1.0 AMENDMENTS TO HOTEL USE

PROJECT
London Road Fire Station

TITLE
Proposed First Floor Plan

2.0 AMENDMENTS TO DRILL TOWER
OVERVIEW OF AMENDMENTS

TITLE
Proposed Third Floor Plan

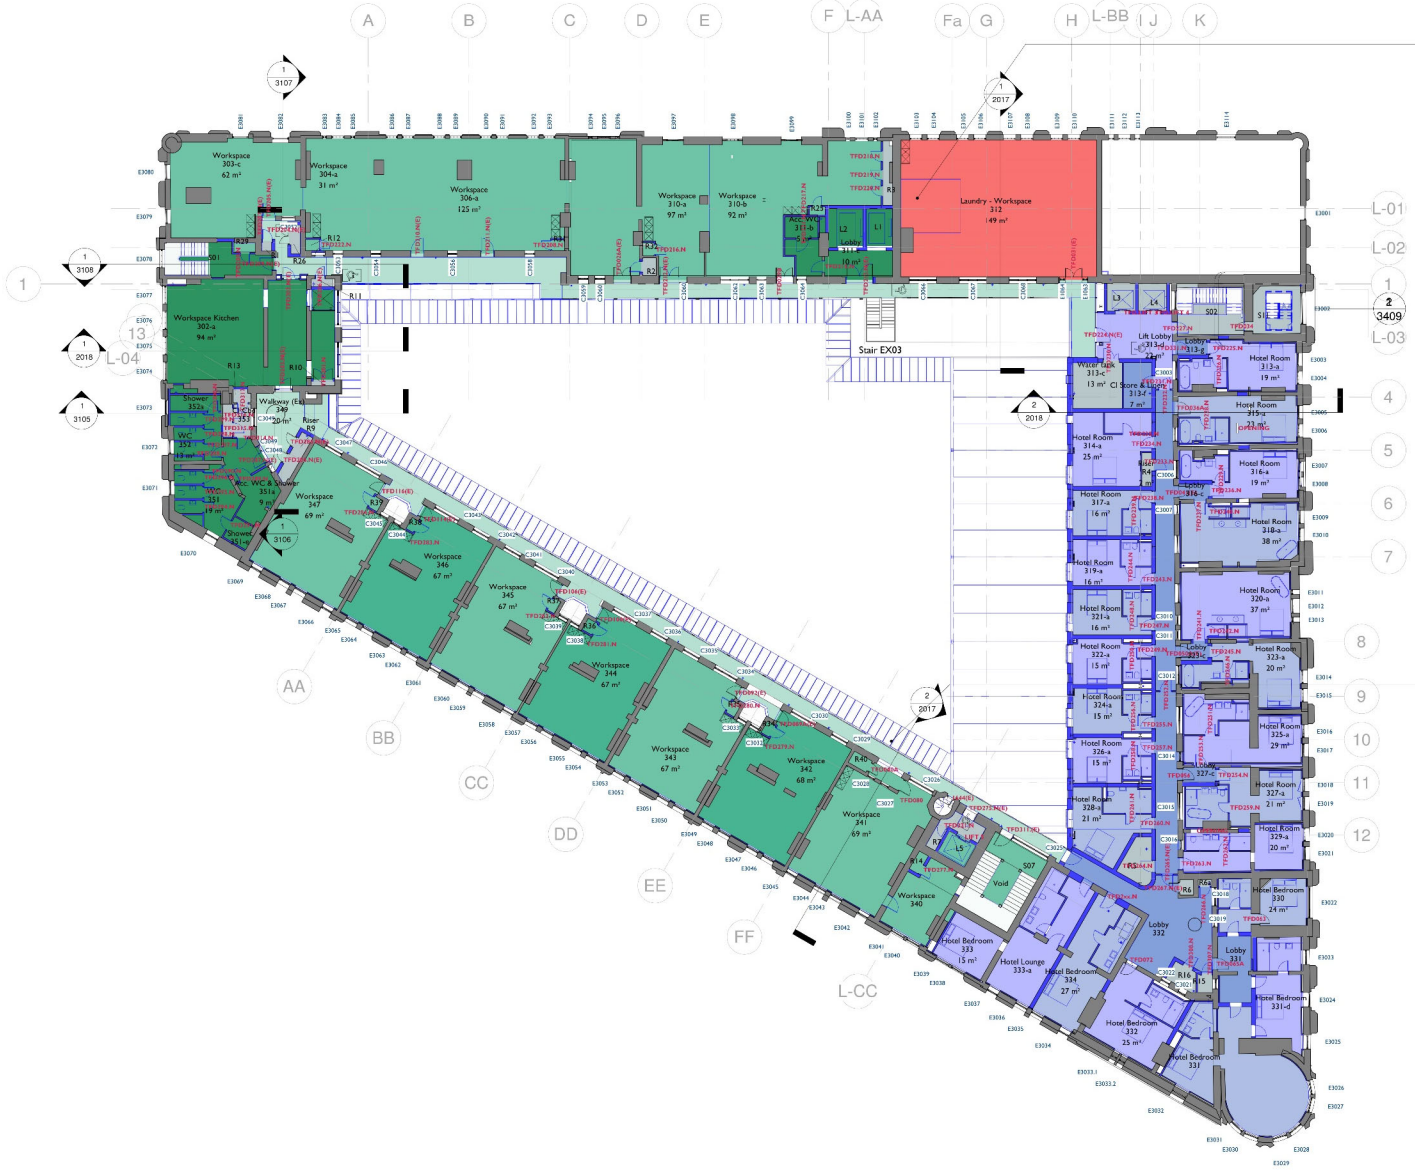
Rev Note 20

Hotel changes - increase number of bedrooms

Hotel Entrance Visuals (consented)

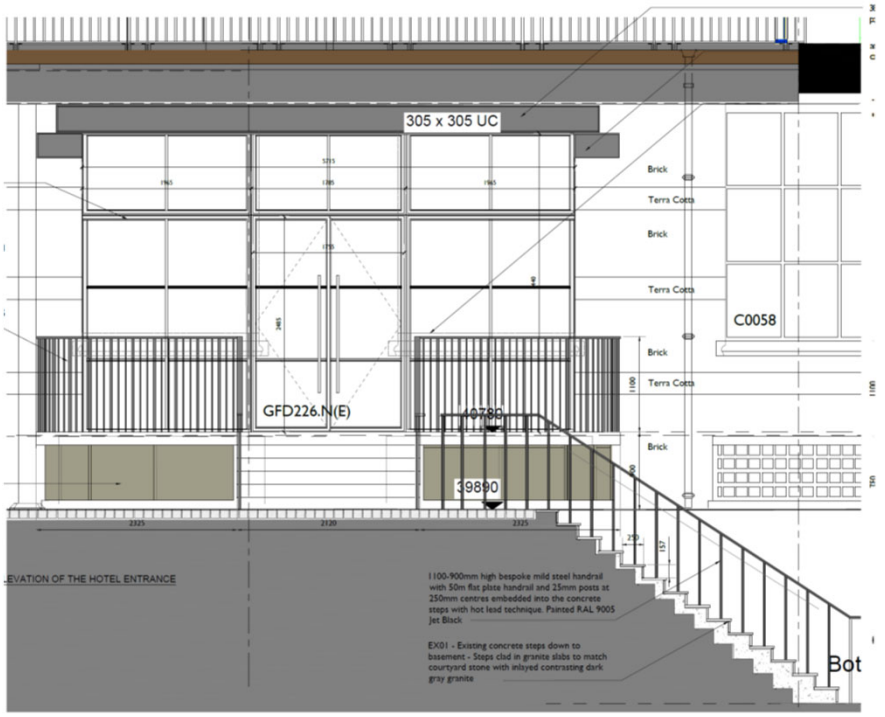
- ADDITIONAL ENTRANCE TO WORKSPACE USE WITHIN DRILL TOWER
  - Previously consented 2017 scheme included two new openings at the base of the Drill Tower
  - Provides main dedicated entrance to workspace uses at upper floors (this has viability and compliance benefits)
  - Detailing of new entrance to follow the design principles set by the hotel entrance (previously presented and agreed)

Ground Floor

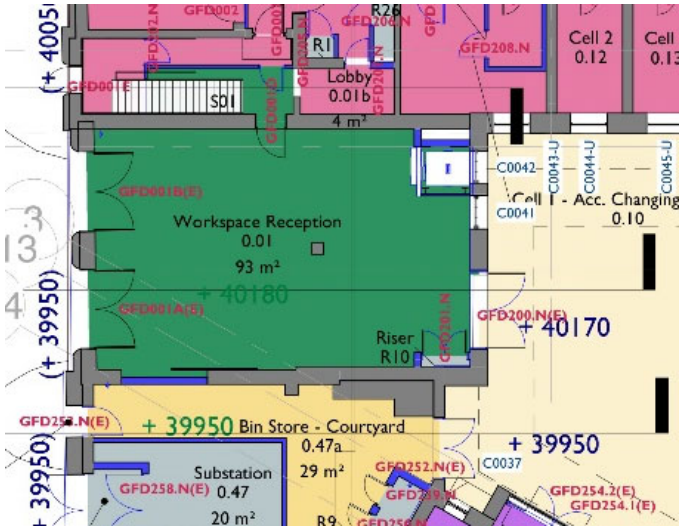
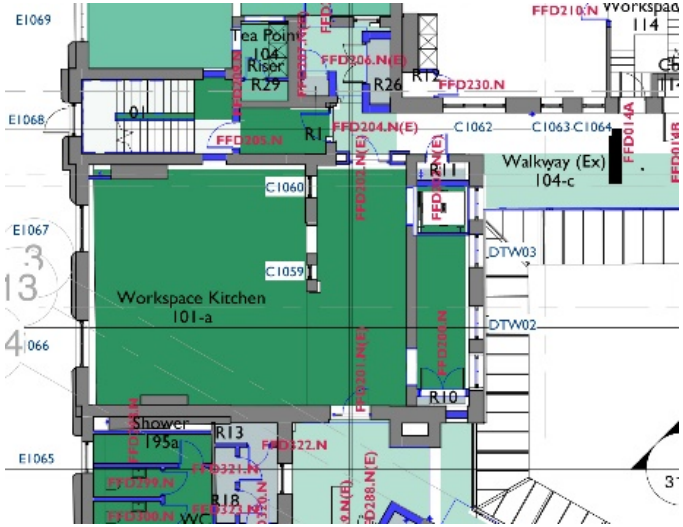
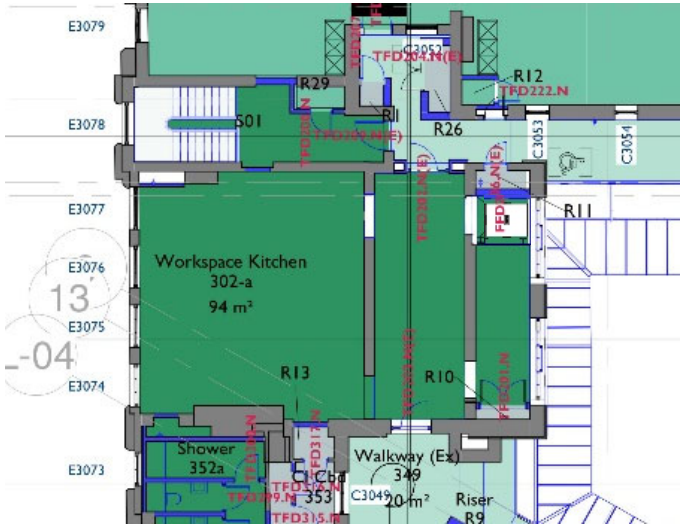
- INCREASE OF HOTEL USE TO 61 ROOMS
  - Some additional subdivision and insertion of bathrooms
  - Logical division of the building (full London Road elevation)
  - Retention of more significant interior spaces
  - Fewer rooms than the 2017 consented scheme
  - Enhanced viability of the hotel use
  - Heritage impact is low adverse

- ADDITIONAL ENTRANCE TO WORKSPACE USE WITHIN DRILL TOWER
  - Previously consented 2017 scheme included two new openings at the base of the Drill Tower
  - Provides main dedicated entrance to workspace uses at upper floors (this has viability and compliance benefits)
  - Detailing of new entrance to follow the design principles set by the hotel entrance (previously presented and agreed)
  - Some loss of heritage fabric (removal of windows and lowering of sill to form door opening), however adjacent windows remain for legibility of the original elevation, and benefits in terms of long-term viability of upper workspaces
  - Heritage impact is low-medium adverse

- ADDITIONAL LIFT WITHIN DRILL TOWER TO SERVE WORKSPACE USES
  - Viability, compliance and accessibility benefits
  - Some loss of heritage fabric (formation of openings within internal walls), however external elevations are unaffected bar back-painting of windows, legibility of the drill tower structure remains, and benefits in terms of long-term viability of upper workspaces
  - Heritage impact is low adverse
